Service Bulletin

Bulletin No.: 20-NA-078

Subject: Malfunction Indicator Lamp (MIL) Illuminated - DTC P0741 Set

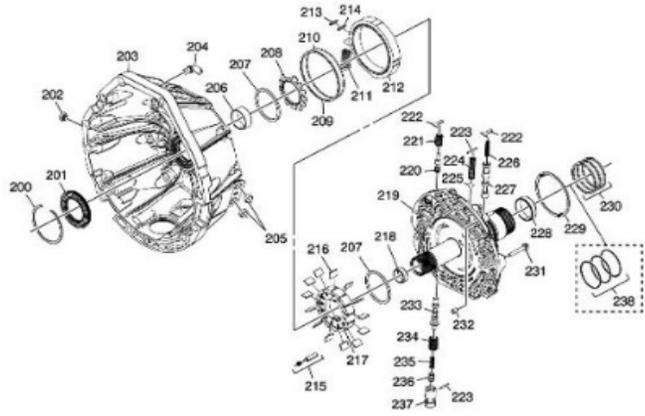
<p>Cause</p>	 <p style="text-align: right;">5448383</p> <p>This condition may be caused by the turbine shaft finish wearing out the turbine shaft bushing (218) and causing a pressure leak path for the T/C clutch apply. – The fit of the turbine shaft seal thru the bushing will have excessive clearance.</p>
<p>Correction</p>	<p>If the fit of the bushing to turbine shaft is excessive the 4-5-6 clutch housing with turbine shaft and the pump cover with the turbine shaft bushing should be replaced.</p>
